SUBJECT: HOPE CREEK GENERATING STATION - EVALUATION OF RELIEF REQUEST  
HC-RR-B08 (TAC NO. MB7839)

SAFETY EVALUATION BY THE OFFICE OF NUCLEAR REACTOR REGULATION

REQUEST FOR RELIEF HC-RR-B08

HOPE CREEK GENERATING STATION

# **ATTACHMENT 1** **ASME Code Case N-613-1 Figure 2**

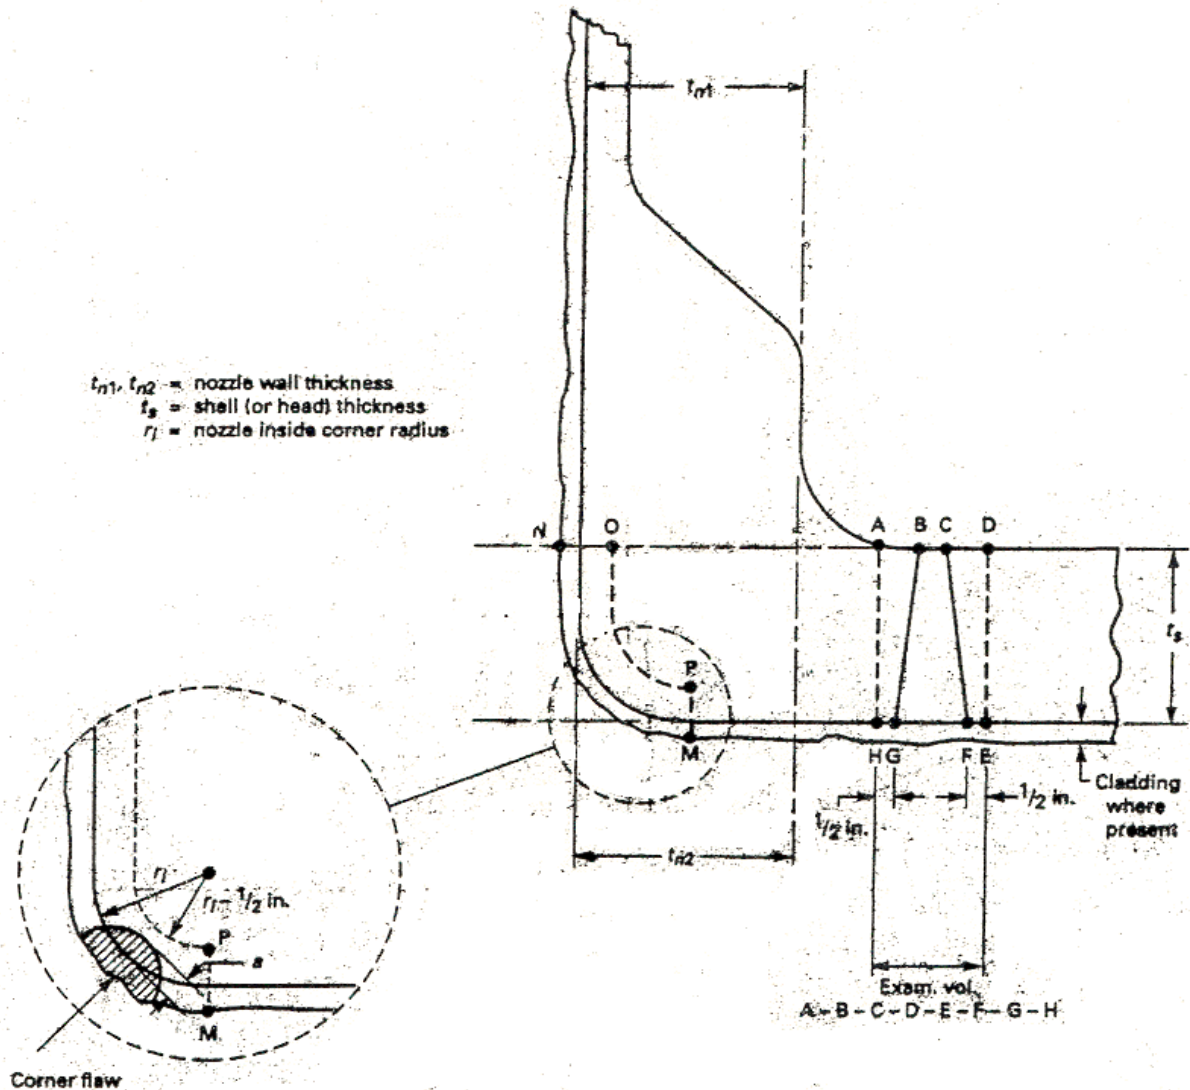
At the request of the staff, PSEG provided a supplemental sketch showing the specific configuration of the nozzle-to-vessel weld and the revised examination volume, as well as a listing of all nozzle-to-vessel welds included within the scope of this relief request. The specific

weld configuration and revised examination volume are depicted as region A-B-C-D-E-F-G-H within Figure 2 of ASME Code Case N-613-1 (Attachment 1). All nozzle-to-vessel welds included within the scope of this relief request are of the type depicted in Figure 2 of Code Case N-613-1. The revised examination volume depicted in this sketch extends to one-half inch from each side of the widest part of the nozzle-to-vessel weld and is, therefore, consistent with the licensee's request for the reduced UT examination volume. All other aspects of the UT examination volumes for RPV nozzle-to-vessel welds remain unchanged by the licensee's request.

The acceptability of the reduced UT examination volume is based on prior full volumetric examinations of the welds and base metal, as well as the internal stress distribution near the weld. Prior full volumetric examinations of the nozzle-to-vessel welds included within the scope of this relief request cover the full volume of base metal, extending to a distance equal to one-half the through wall thickness from each side of the widest part of the nozzle-to-vessel weld, as required by the Code. This base metal region included in the original ASME Code volume was extensively examined during construction, preservice inspection, and prior ISIs. These examinations all show the ASME Code volume to be free of unacceptable flaws. The creation of flaws during plant service in the volume excluded from the proposed reduced examination volume is unlikely because of the low stress in the base metal away from the weld. The stresses caused by welding are concentrated at, or near, the weld. Cracks, should they initiate, occur in the highly stressed area of the weld. These areas are within the volume included in the reduced examination volume proposed by PSEG. The prior full volume examinations of the base metal provide the appropriate assurance that these areas are free of unacceptable flaws.

PSEG will perform the UT examination of the specified nozzle-to-vessel welds from the outer diameter of the vessel welds using manual ultrasonic methods. This will allow for the extremities of the nozzle-to-vessel welds to be precisely located, thereby assuring complete coverage of the modified examination volume on each side of the weld crown. PSEG has documented the precise locations of repaired areas for all RPV nozzle-to-vessel welds at Hope Creek. Based on a review of the documentation, and associated drawings of repaired areas for all RPV nozzle-to-vessel welds, PSEG determined that all weld repairs are encapsulated within the existing nozzle-to-vessel welds. The inclusion of repaired areas for all RPV nozzle-to-vessel welds within the reduced examination volume will provide adequate coverage of these areas of higher stress.

Based on the above discussion, the staff finds that the areas to be excluded from UT examination by the relief request have previously been found to be free of unacceptable flaws by examinations performed during inservice inspection and fabrication. The staff further finds that the initiation of flaws in these regions, subsequent to the performance of said examinations, is highly unlikely due to the lower weld-induced stresses in these regions. Therefore, the staff finds that the proposed alternative to reduce the UT examination volume to one-half inch from the widest part of the nozzle-to-vessel weld on each side of the weld crown will provide an acceptable level of quality and safety.
